Service Info

Repair kit 530 0550 10

for second-generation VAG common-rail diesel engines

Image 2: Deflecting pulley 532 0623 10 (left)/deflecting pulley 532 0349 10 (right)

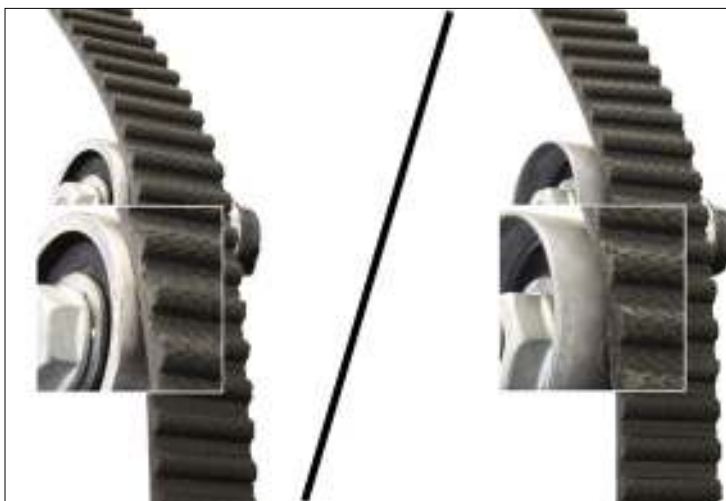
All specified KITS and SETs are equipped with improved deflecting pulley 532 0623 10 (image 2, left). This pulley replaces deflecting pulley 532 0349 10 (image 2, right) used in the vehicles listed.

Compared with the previous model, the optimised deflecting pulley is some 6.6 mm narrower. As a result, the toothed belt runs over the pulley in a central position, ensuring force is distributed much more effectively on the ball bearing. By making this change, the pulley has been adapted for the conditions faced by this timing assembly.
